ADDENDUM NO. 6
To the Contract Document and Project Specifications for the
Wayne High School Campus Improvements
Fort Wayne Community Schools (FWCS)
Fort Wayne, Indiana
November 18, 2025

The items in this addendum are to become a part of the original documents as if included therein. The remainder of the original contract document is to remain in its entirety. This Addendum modifies the Contract Documents and Specifications as follows:

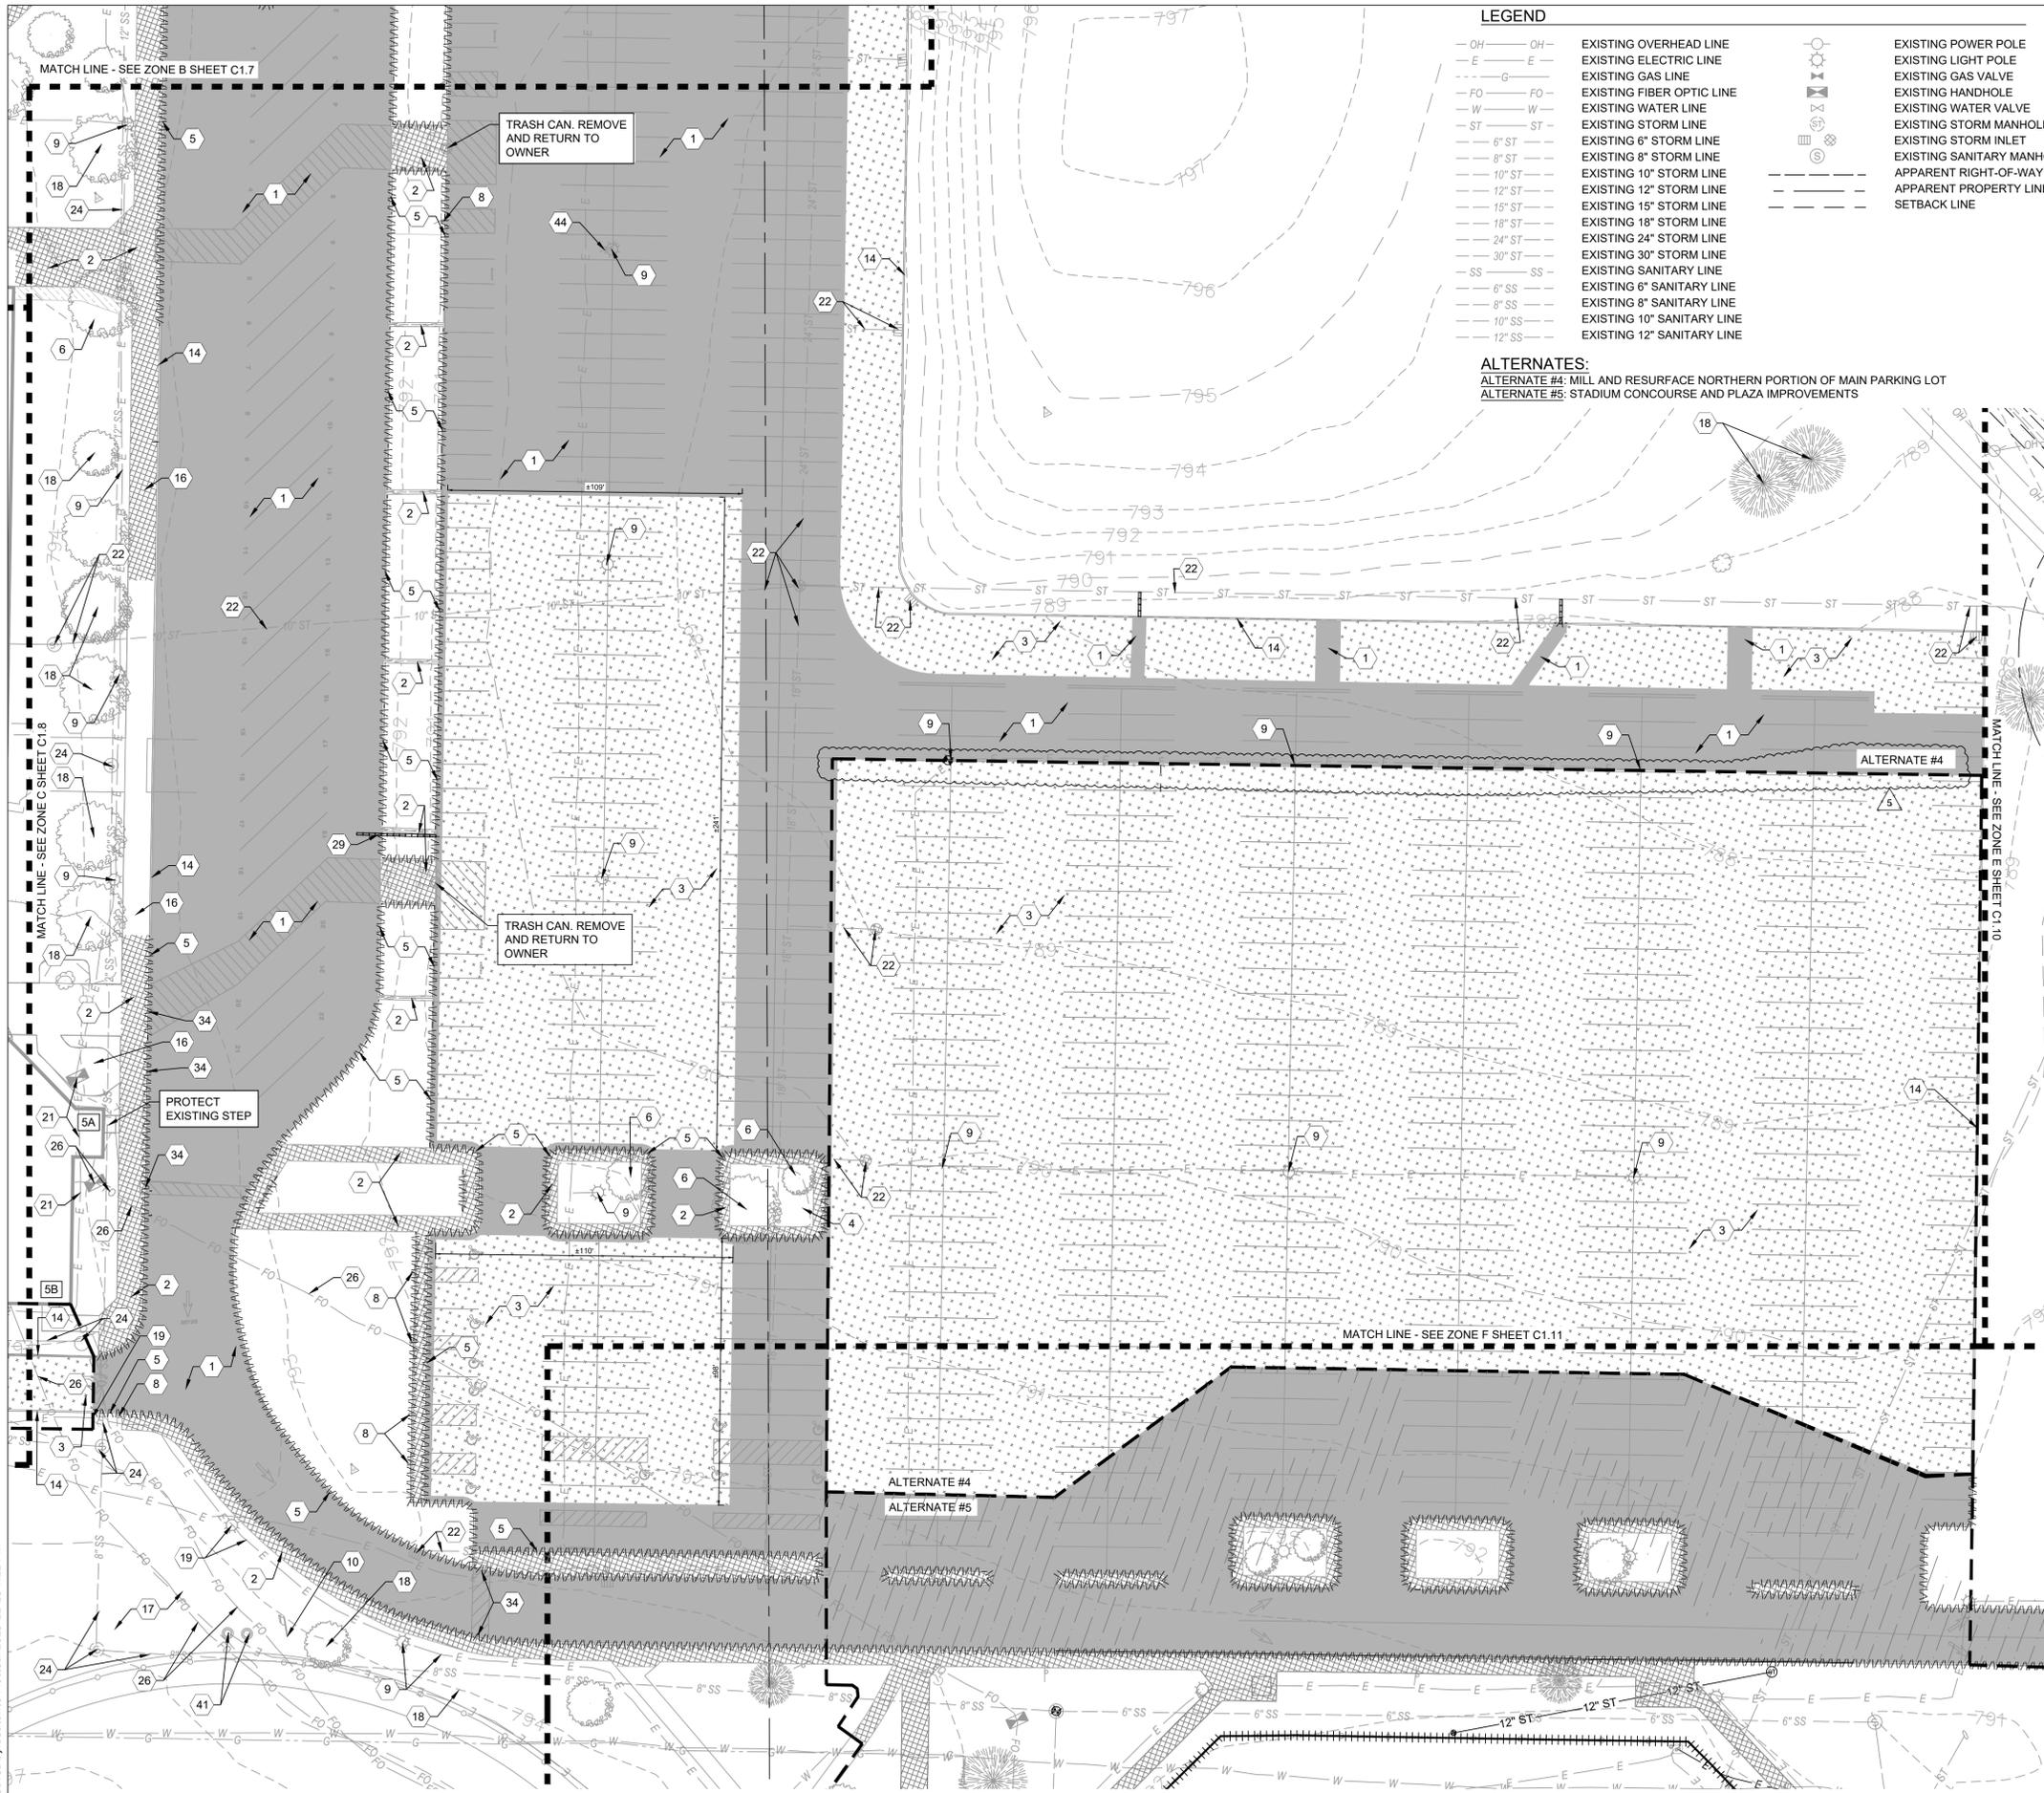
1. *Is the rock mulch shown under the detention basin buffer fence to be included in the base bid.*
 1. Yes, the rock mulch under the detention basin buffer fence is to be included in the project base bid.

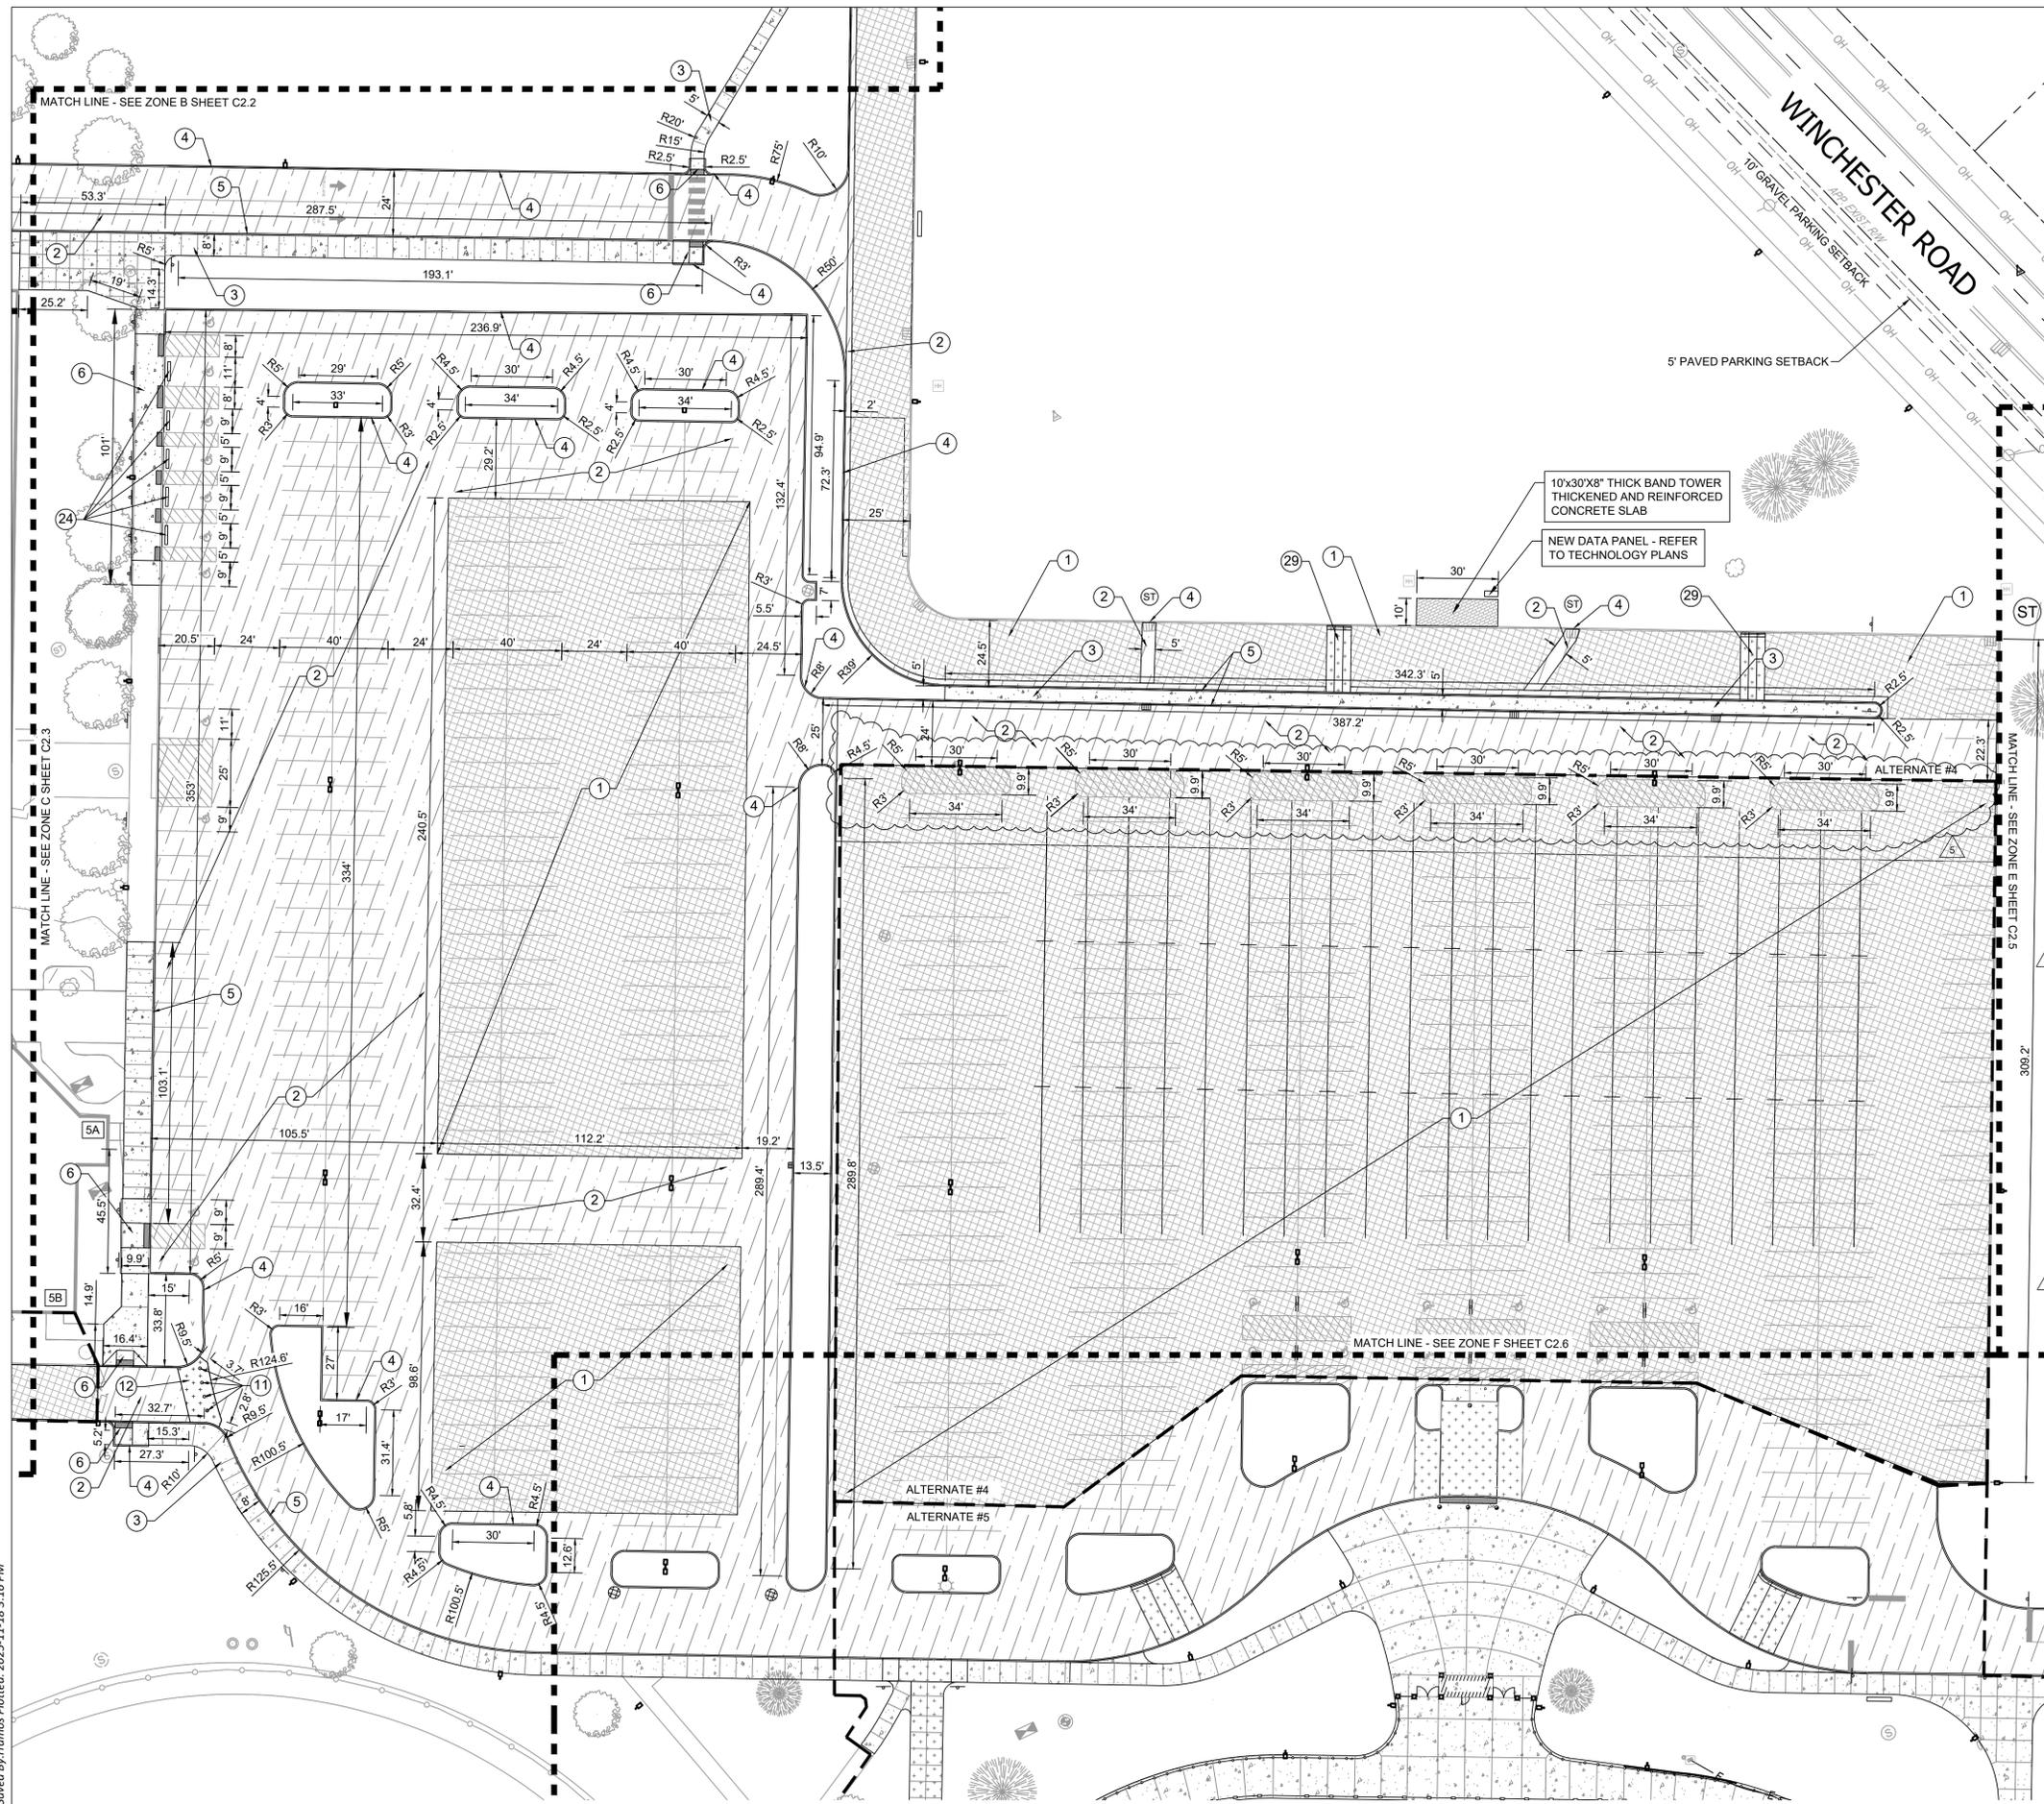
2. Plan Sheet C2.4 –Site Dimensional Plan – Zone D
Revised: Alternate #4 boundary

DESIGNED BY: JJB
 REVIEWED BY: CEE, AC
 DRAWN BY: JJB
 REVIEWED BY: CEE, AC
 DATE: NOVEMBER 7, 2025
 JOB NUMBER: 2025-01487
 HORIZ. SCALE: 1" = 100'
 VERTICAL SCALE: N/A
L1.0

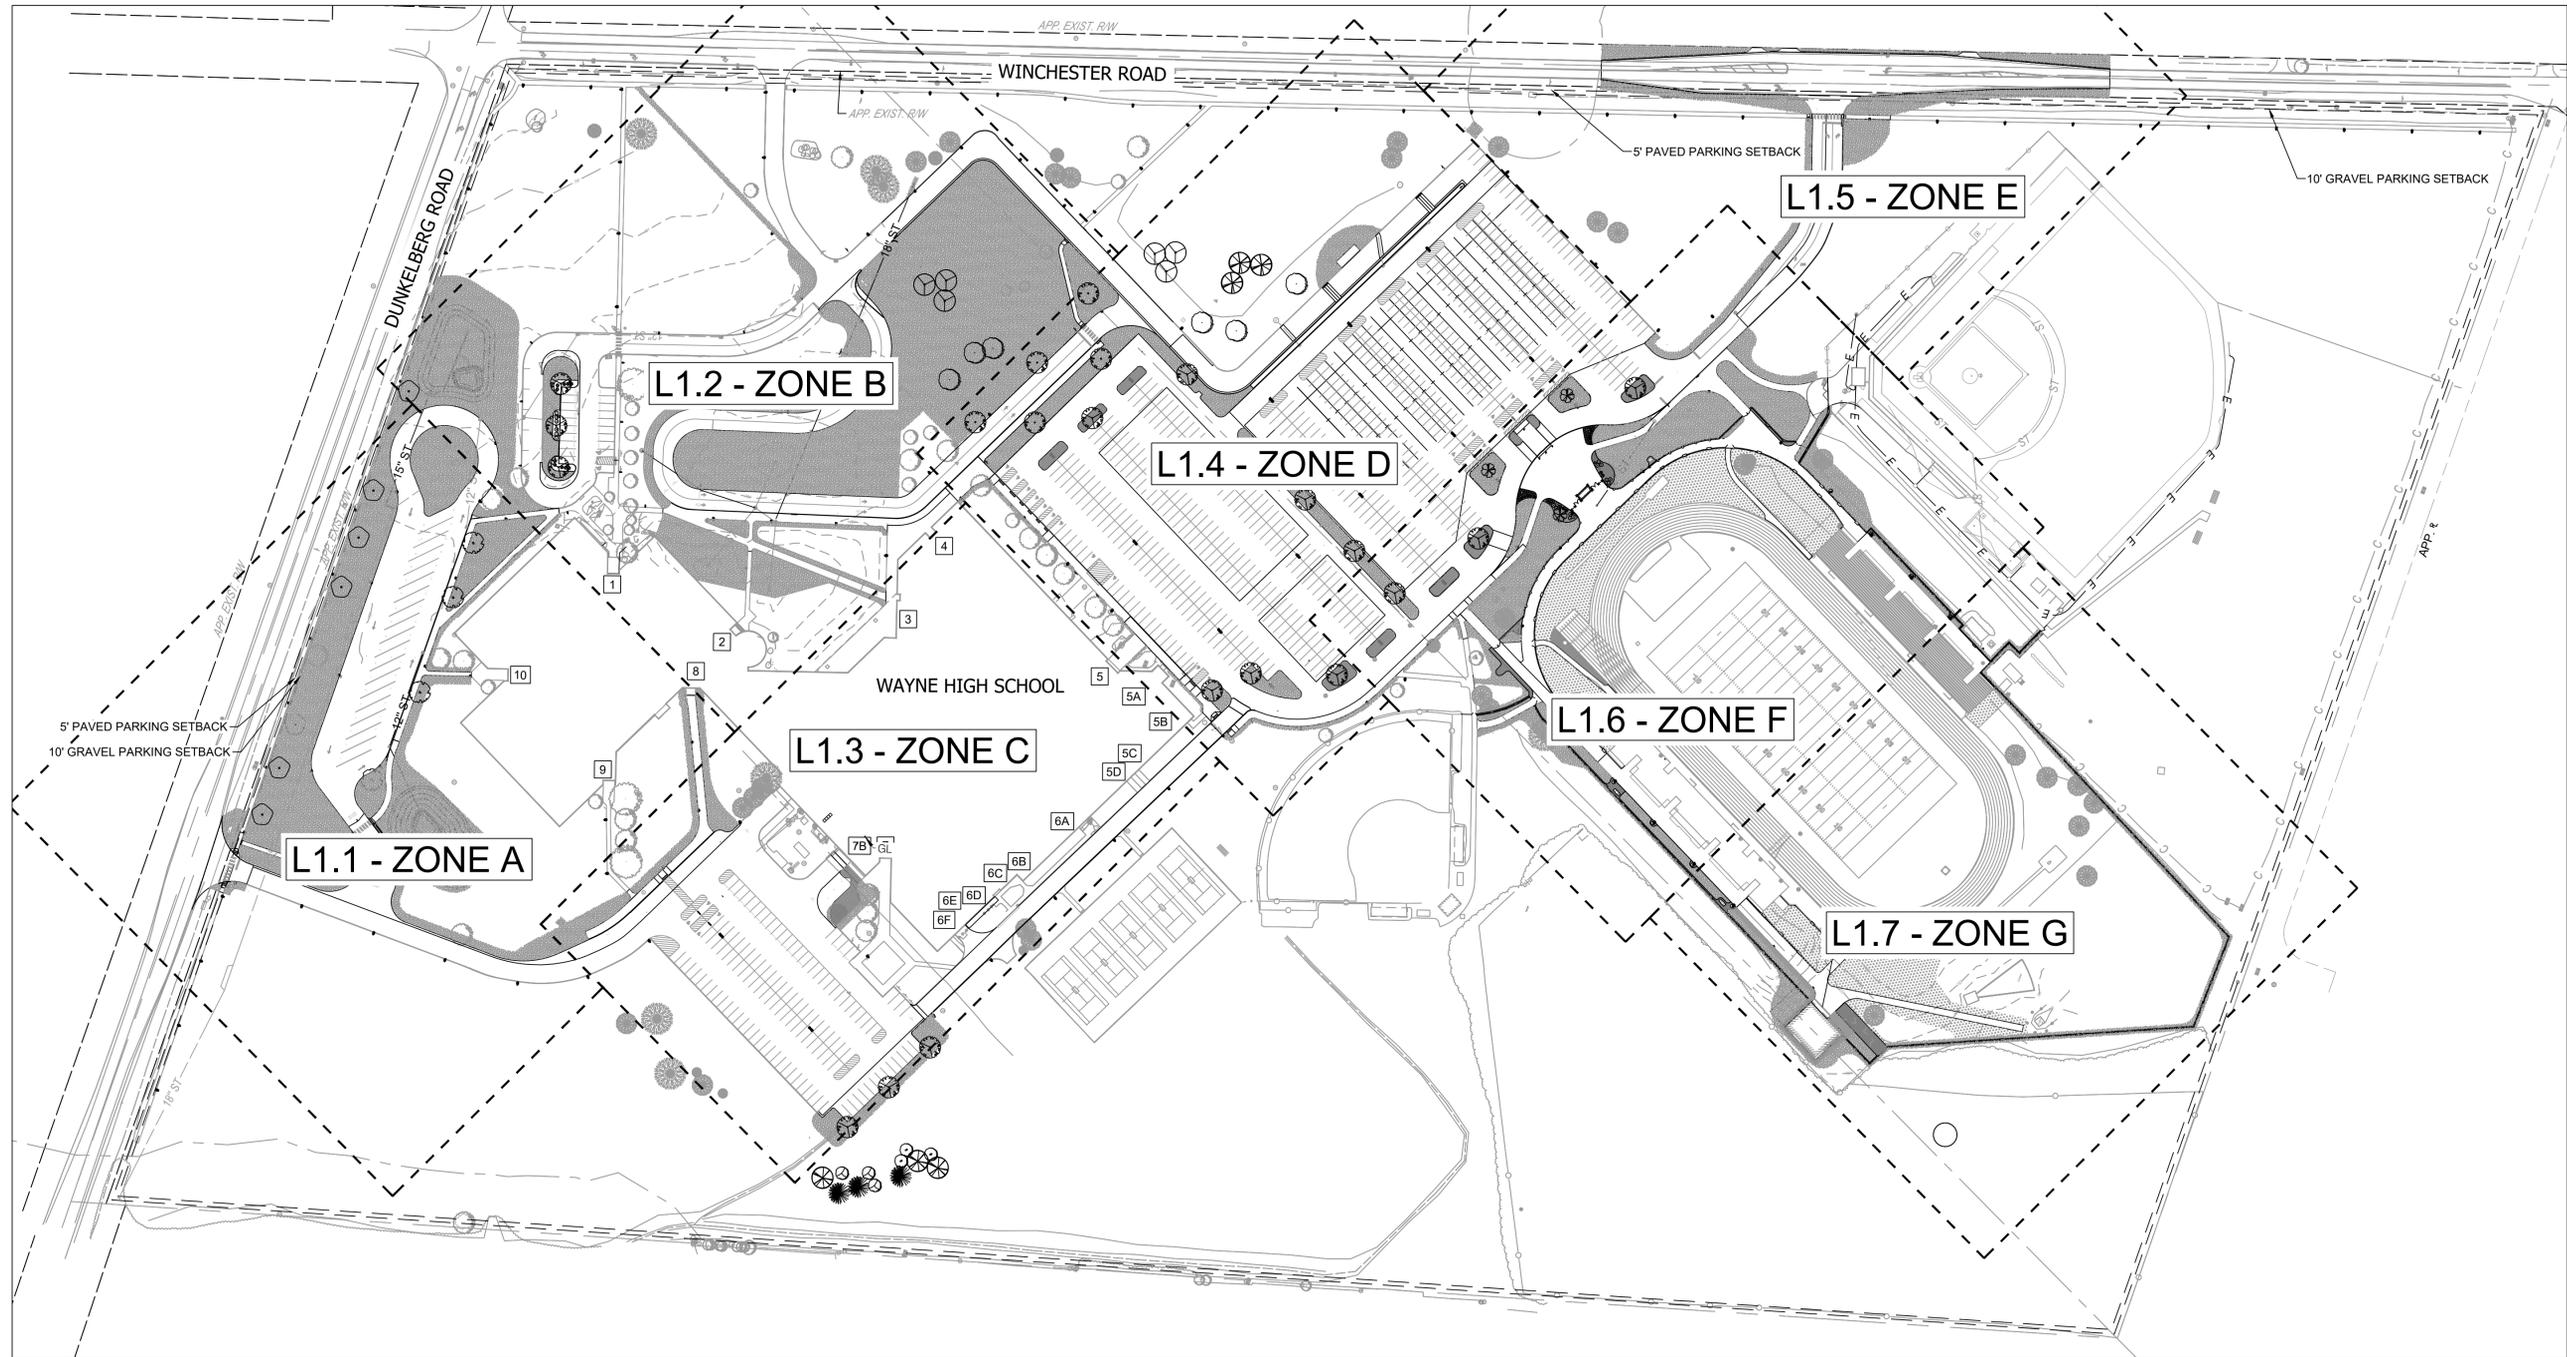
4. Plan Sheet L1.0 – Landscape Plan Overall
Revised: Evergreen Tree sizes to be “6’ H MIN.”
